**BIG HORN COAL COMPANY
10980 SOUTH JORDAN GATEWAY
SOUTH JORDAN, UT 84095**

RE: Objections to Proposed Brook Mine Permit Application, Sheridan County, Wyoming

Objection No. 1 – Surface Owner Protection Bond Review

Big Horn Coal Company 10980 South Jordan Gateway South Jordan, UT 84095	
ATTACHMENT 1	
Sheridan County, Wyoming State Plane NAD 83 WYCC	
Drawn By: J. Sweezy	Scale: 1:18,000
Approved By:	Date: 4/21/2020
Revision:	Draw No.:
BHCC_Attachment_1

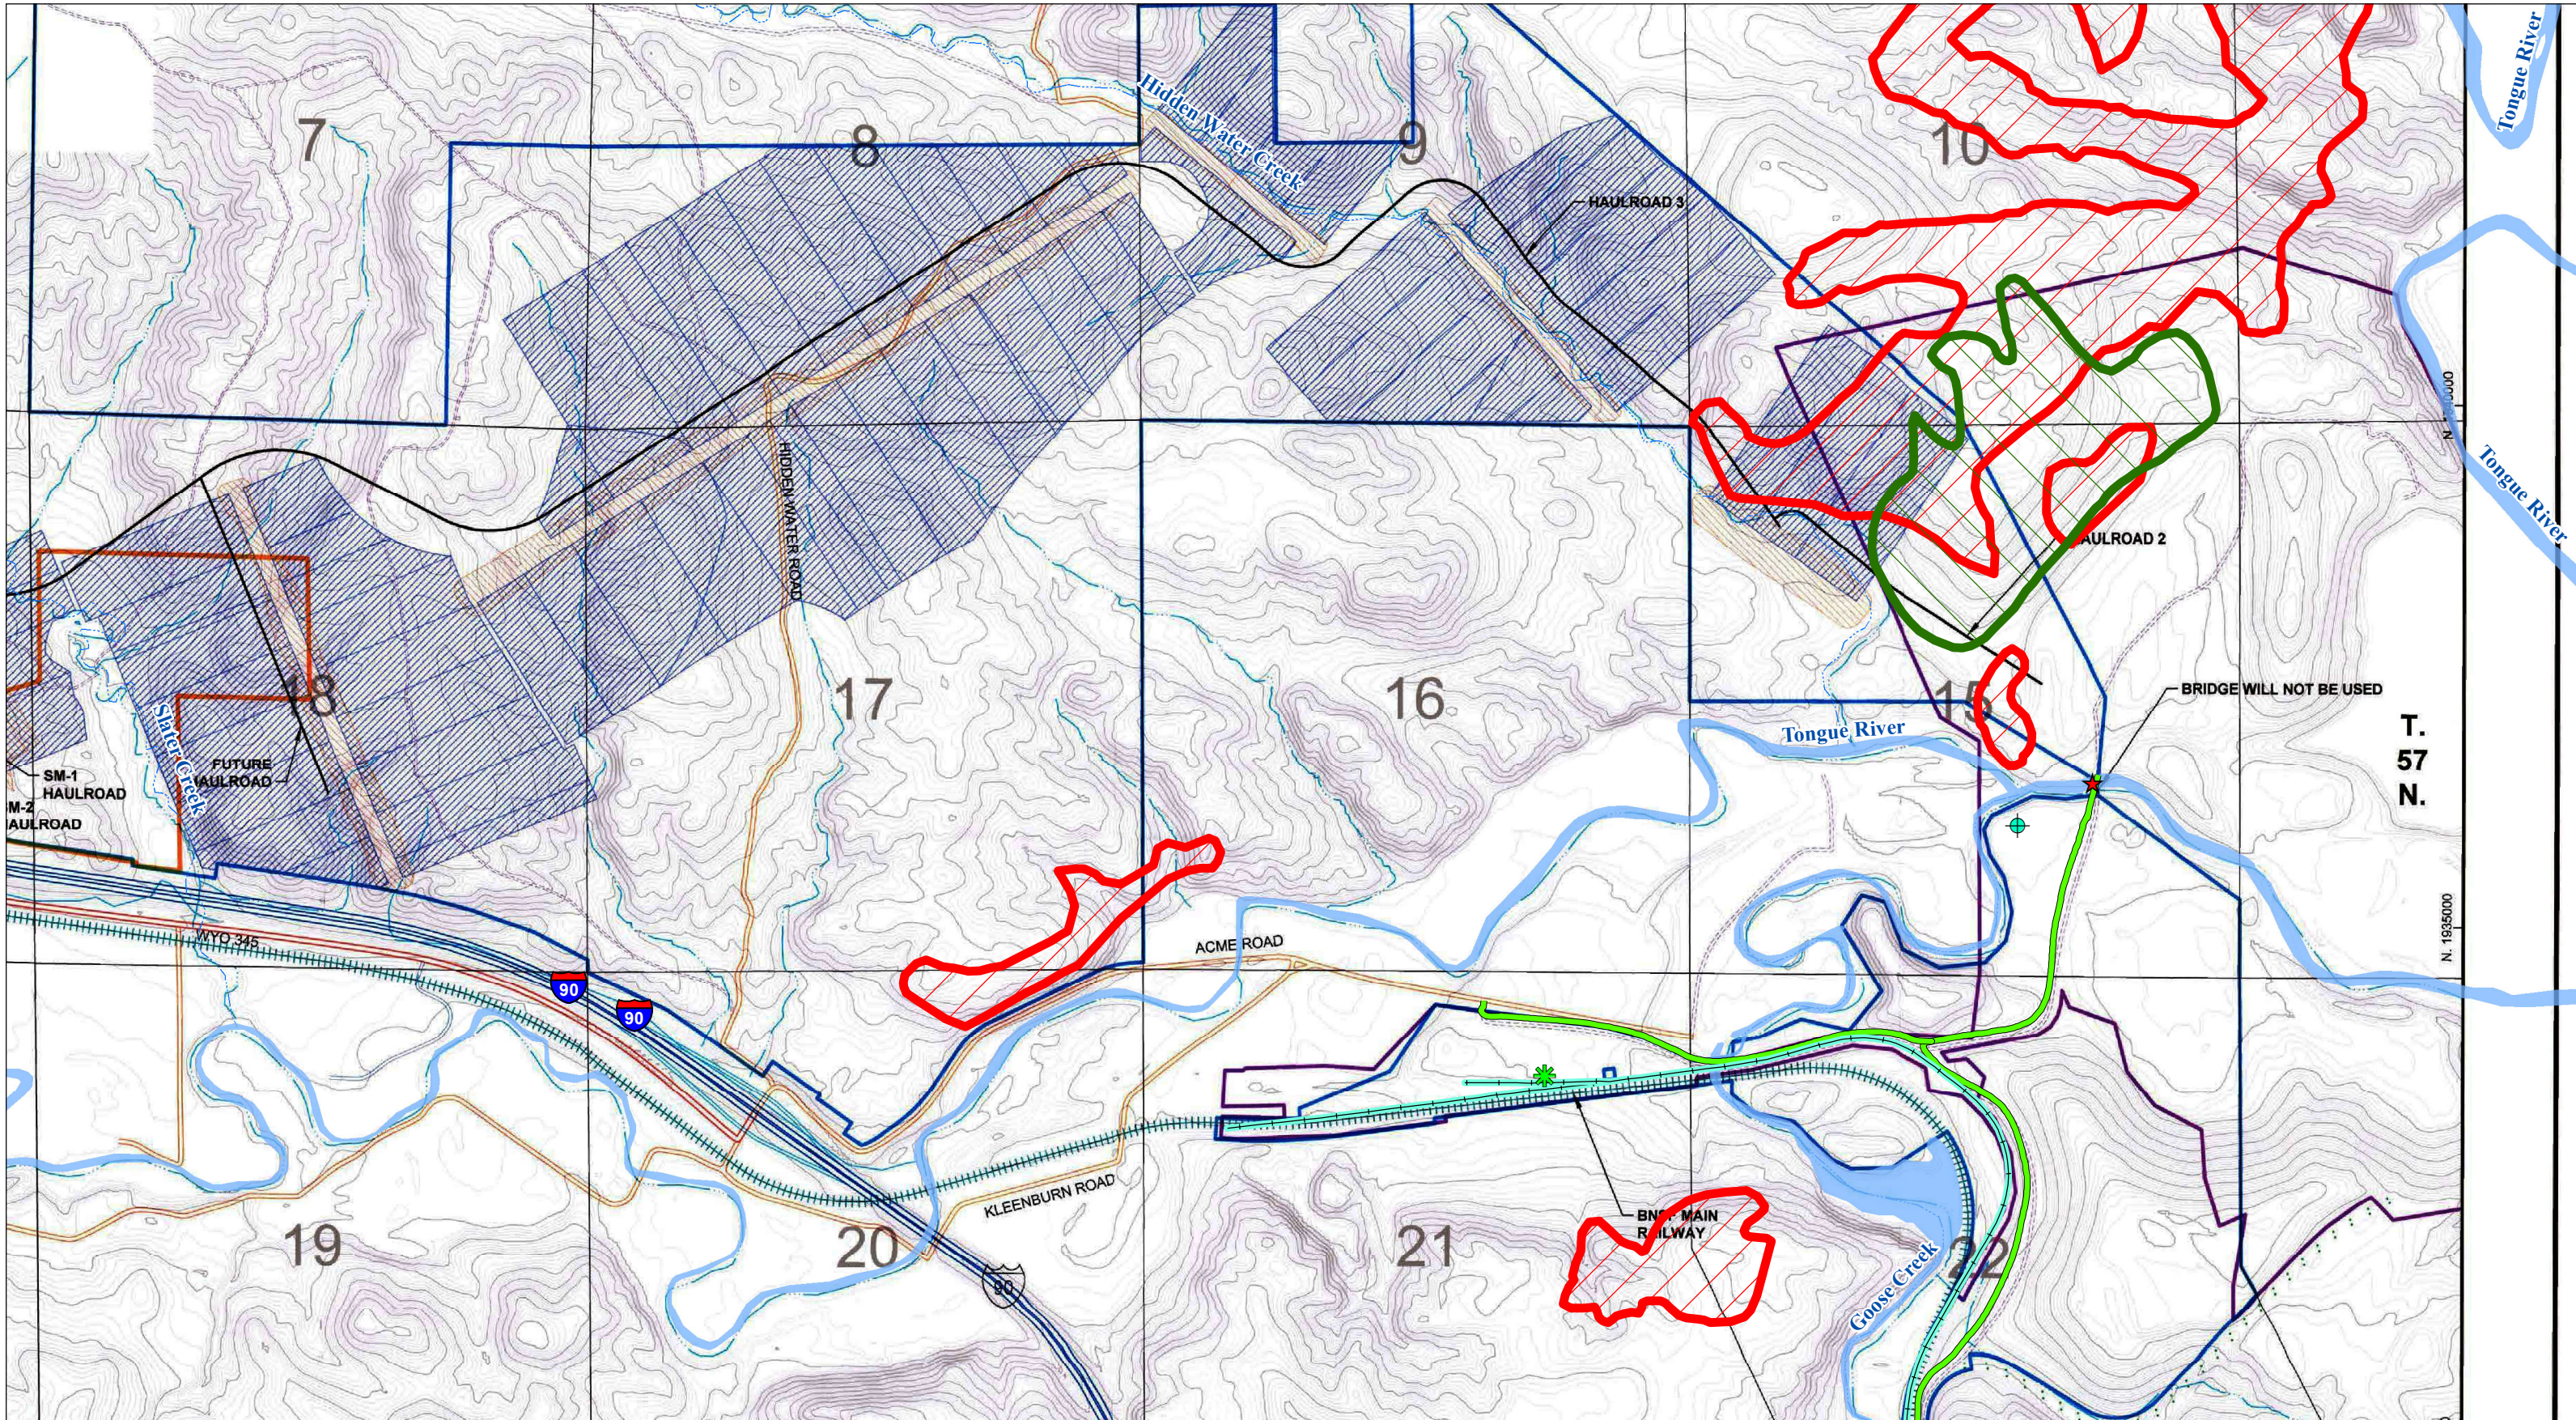
The fire control plan referenced in Section MP.11 and presented in Addendum MP-5 describes measures to be taken to prevent and control fires in the mine pits, fires in the mine's processing and shop facilities, equipment fires and rangeland fires. BHCC objects, however to the proposed Mine Plan and Addendum MP-5 not providing plans to control and extinguish new subsurface coal fires that may develop or existing subsurface coal fires that may become rekindled or enlarged as a result of the highwall mining panels that will be opened outboard of the highwall trench openings.

Attachment 1 provided with this Objection No. 4 is a drawing showing the approximate extent of underground coal mine fires in the area of proposed highwall mining in Sections 10 and 15, T57N, R84W, as reported by the U.S. Geological Survey in 1980. The fires in this particular area originated with mining of the Monarch coal seam. This and other nearby historic underground mines have long been known to exhibit numerous subsidence features and underground coal mine fires, and in the late 1980s BHCC received approval from the WDEQ/LQD to permanently place nearly 10 million bank cubic yards of overburden over the area shown on Attachment 1 in an attempt to reclaim the subsidence and control the fire. That unique reclamation feature is known as the Pit 3 Subsidence Dump in Big Horn Mine's reclamation history. The proposed highwall mining will develop mine openings in the Carney and Masters coal seams beneath the Monarch seam in areas that are known to still exhibit evidence of underground coal fires. Plumes of steam and smoke have been observed again over the general area of Sections 10 and 15 this winter of 2016-2017. These observations indicate that, in certain places, the perimeter of the historic subsurface coal seam fires has expanded notable distances from the referenced 1980 boundary delineation.

Objection No. 4 above introduces the fact that the underground mine fires in this area are still burning and have expanded. Section MP.15 does not, in any way, address that the burned areas have expanded. A surface mine excavation that comes in contact with a historic mine fire could be catastrophic in many ways, including: impacting the safety of mine workers, damage to equipment, wildfire initiation, etc. BHCC believes this proposed Mine Plan has not adequately addressed surface mining activities that will occur near underground mines and insists that the Brook Mine operators must perform the necessary testing and analyses to prove that the proposed Mine Plan will not be impacted by historic mine fires. Specifically, attachment 1 provided with Objection No. 3 above shows that trench TR-1 is planned very near an area that was burning and is likely still burning. Given that the burned area has likely expanded, this area should not be disturbed at all.
